**IMPROVEMENT : Spark plug, Handle, Coil assy,
A/C cover and Case assy**

Model : GZ3500T

GZ3500T's parts have been changed from the production in July and September 2010. Those parts changes are for improvements in quality.

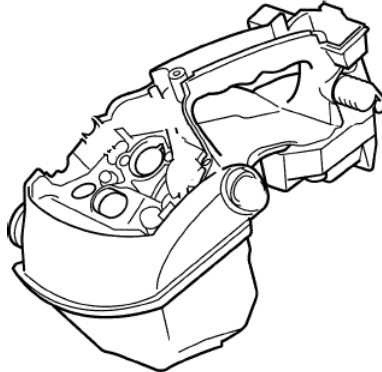
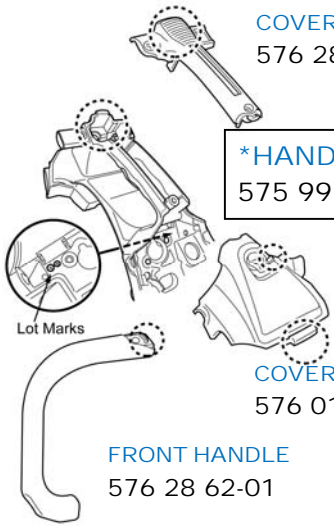
Handle, Front handle, Cover grip & Cover comp

Spark plug, Coil assy & Case Assy

No	OLD P/N	Interchangeability	NEW P/N
1	 <p>COVER, grip 522 64 19-01 (848CE033L2)</p>  <p>COVER, comp 522 64 68-01 (848CE08322)</p>  <p>FRONT HANDLE 522 64 16-01 (848CE032A2)</p>	B	 <p>COVER, grip 576 28 63-01</p>  <p>COVER, comp 576 01 07-01</p>  <p>FRONT HANDLE 576 28 62-01</p>
2	<p style="color: red;">HANDLE, comp 527 66 98-01 (848CE03315)</p> <p><i>discontinued spare part</i></p> 		<p>HANDLE, SET 577 36 44-01</p>  <p>COVER, grip 576 28 63-01</p> <p>*HANDLE, comp 575 99 42-01</p> <p>COVER, comp 576 01 07-01</p> <p>FRONT HANDLE 576 28 62-01</p> <p><small>Lot Marks</small></p>

A Handle, SET(577 36 44-01) will be supplied instead of the Handle,comp for old type of units from now on.

*A new HANDLE comp (575 99 42-01) is also available for the replacement in itself.
